SERVICE BULLETIN

Classification: BT09-079	Reference: NTB10-010	Date: January 19, 2010
-----------------------------	-------------------------	---------------------------

2009 370Z; SEAT POPPING NOISE/SLIGHT MOVEMENT FROM FRONT RIGHT SEAT CORNER

Figure 1

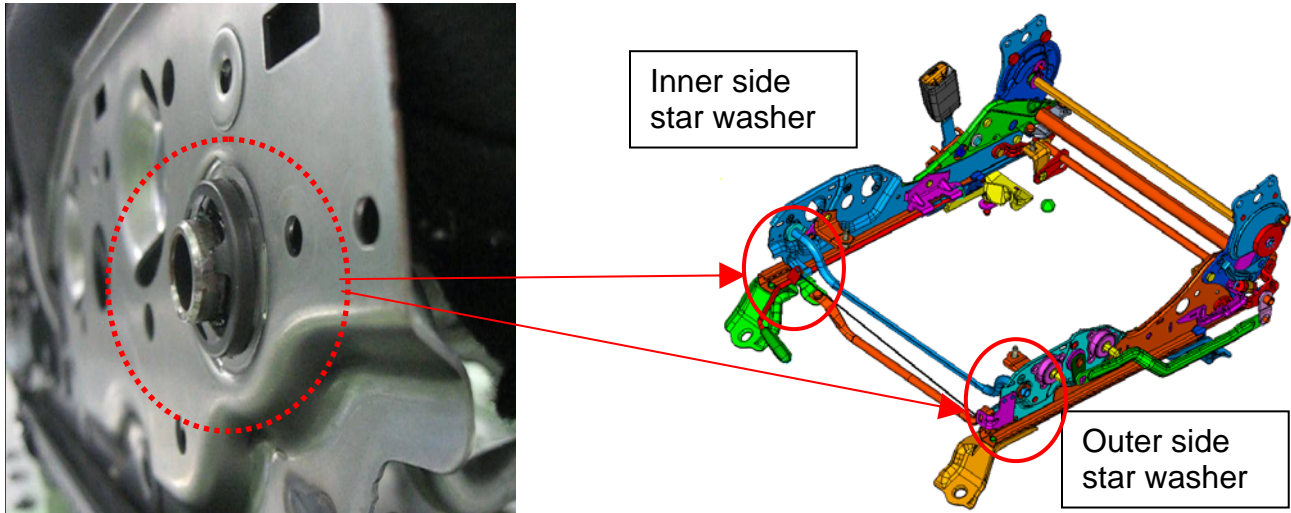
NOTE: Both the inner side AND outer side star washer being replaced in this procedure is shown below.

Replace the push-type star washers of the frame as shown in the Service Procedure of this bulletin.

Figure 4

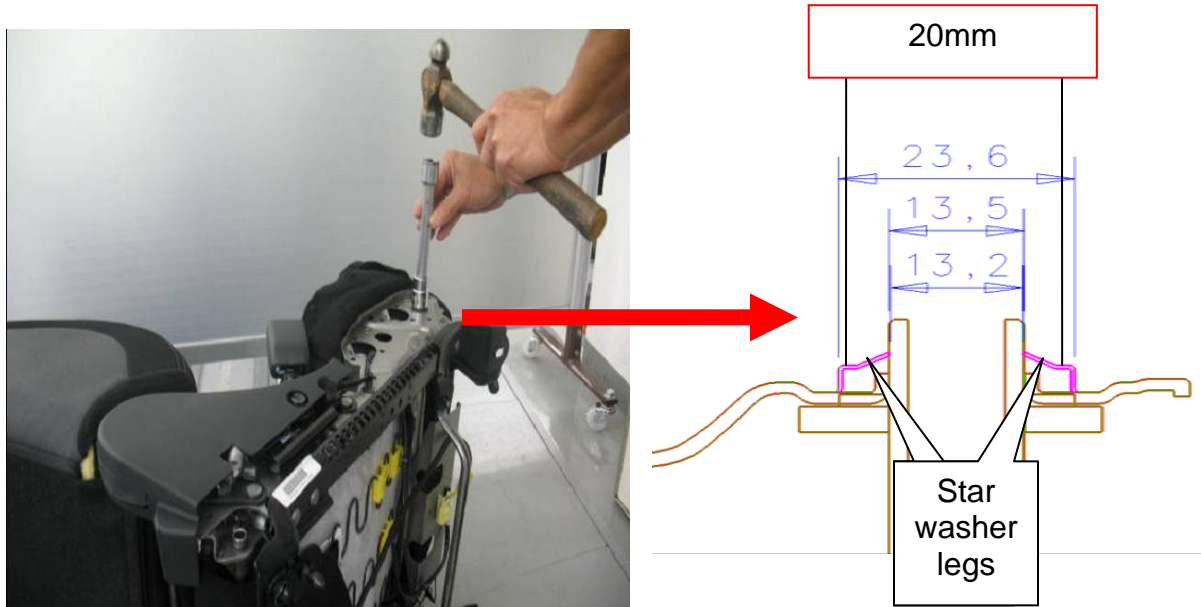
4a. Locate a pipe, socket, or similar tool with an internal dimension (ID) between 20 to 21mm that can be used as a drift. Ensure size is such that it does not interfere with “legs” of star washer (see Figure 4).

4b. Use tool to drive new star washer onto connector bar.

Figure 5

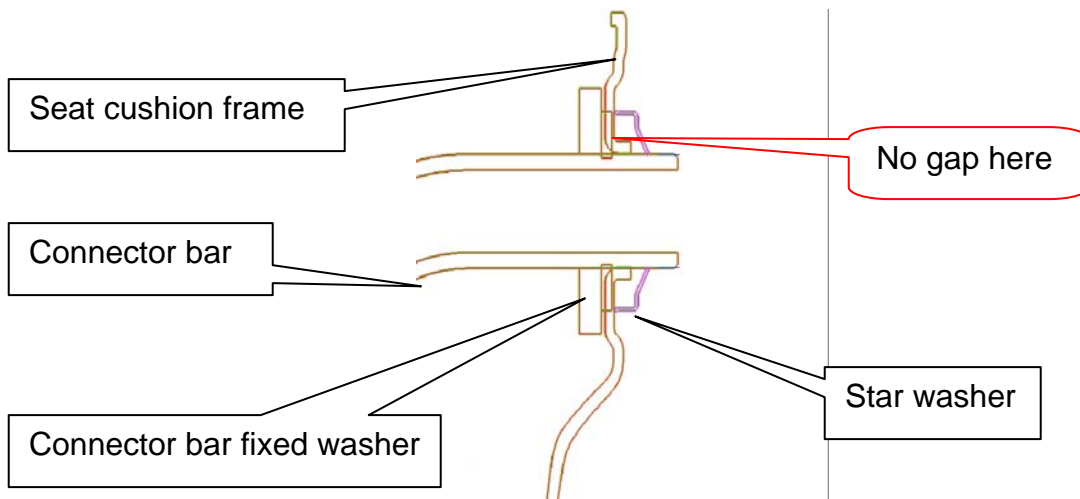
5. After drifting ensure star washer is fully seated against seat frame.
